<b>Docket Number:</b>	14-AAER-02
<b>Project Title:</b>	Computer, Computer Monitors, and Electronic Displays
<b>TN #:</b>	205339
<b>Document Title:</b>	Chris Hankin, Information Technology Industry Council Comments: June Deep Dive Mtg, ITI/Technet Computers Presentation -- Dell Corp
<b>Description:</b>	N/A
<b>Filer:</b>	System
<b>Organization:</b>	Chris Hankin/Information Technology Industry Council
<b>Submitter Role:</b>	Public
<b>Submission Date:</b>	7/13/2015 2:16:04 PM
<b>Docketed Date:</b>	7/13/2015

**June Deep Dive Mtg, ITI/Technet Computers Presentation -- Dell Corp**

# CEC Deep Dive Cost Effectiveness/Technical Barriers

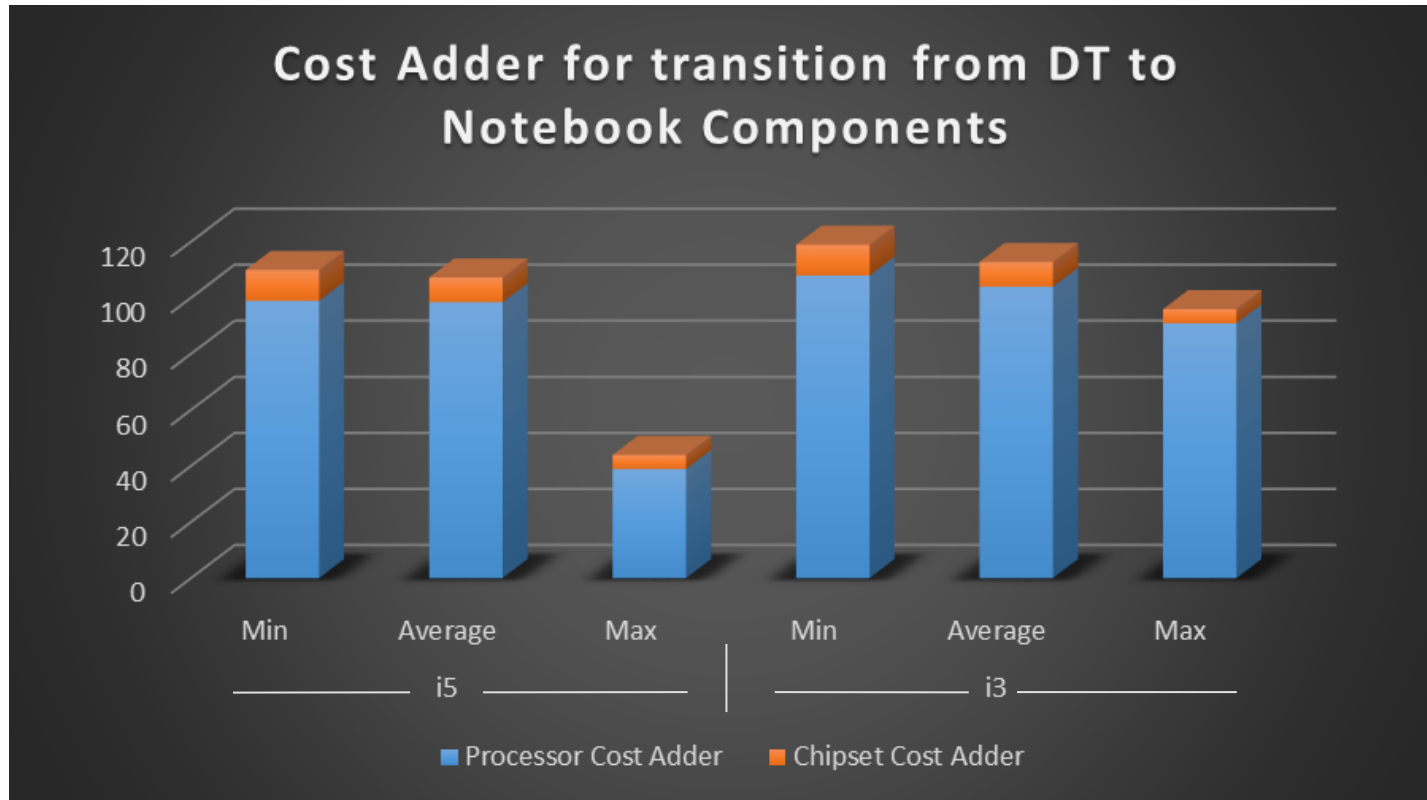
- CEC and IOU's advocate HDD power when platter is spun down
- Referenced test procedure requires HDD platters to remain spinning
- 24-25 kWh required for avg HDD using just short idle on time
- Systems needing high performance drives would require 31 kWh adder
- 2.5in drives 4-6 kWh from specs
- Hybrid 2.5 in drives – 7kWh from spec
